Site Inspection Report

Site: UPRR 43 PAN AM G
CONSOLIDATION #2
04/22/2022

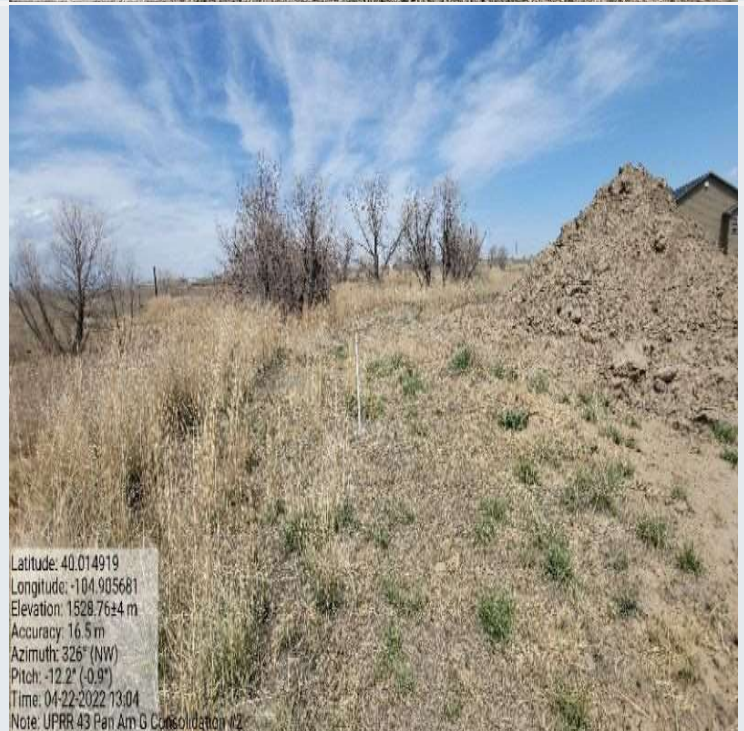
Question: Monitoring well(s) present? If so note number and approximate location

Response: 5

Notes: Stickup – Photos show approximate locations.

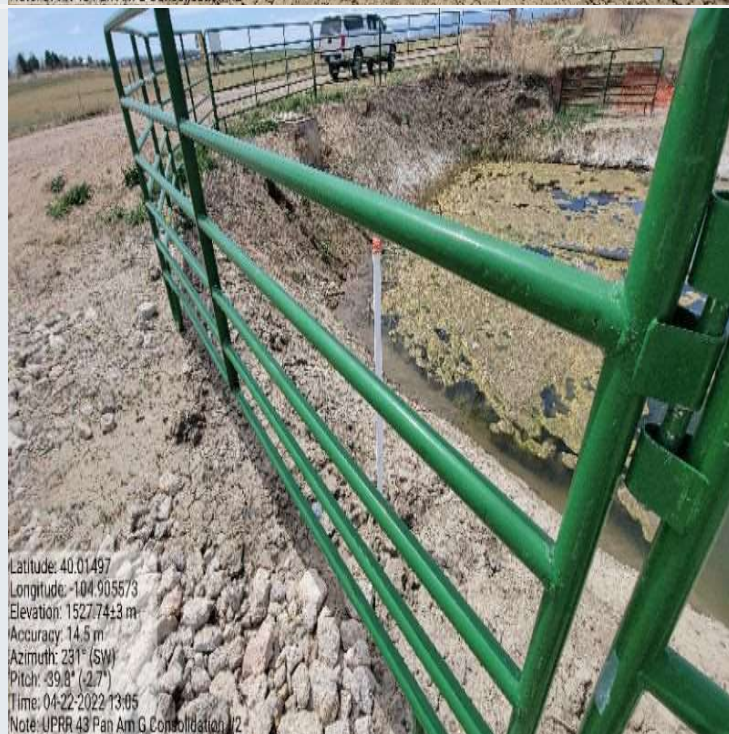
Question: Monitoring well(s) present? If so note number and approximate location

Response: 5

Notes: Stickup – Photos show approximate locations.

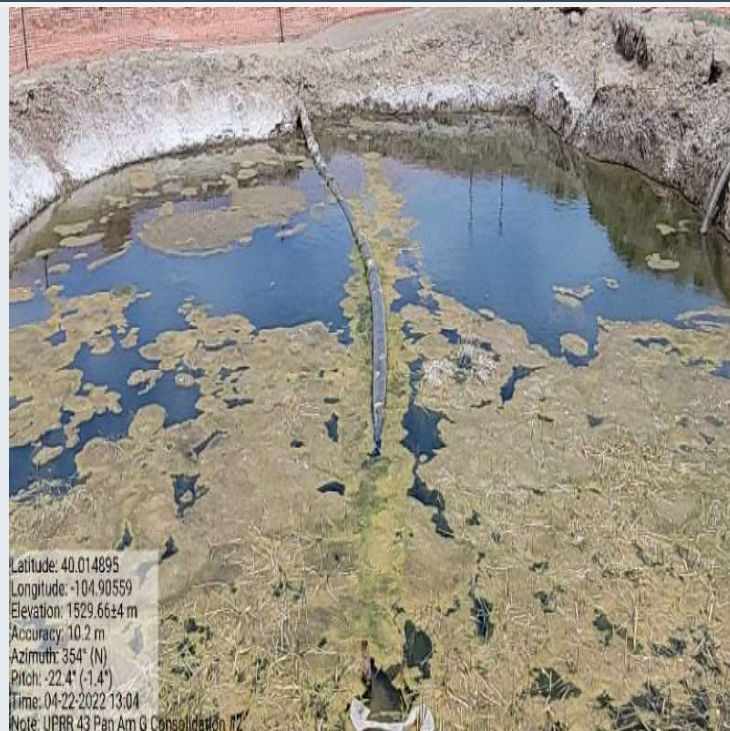
Question: Is fencing adequate/appropriate for site and well maintained?

Response: No

Notes: Construction fencing around a portion of the excavation has fallen and is in need of repair. Another portion of the excavation is not fenced in.

Question: Exposed buried/underground flowlines?

Response: Yes
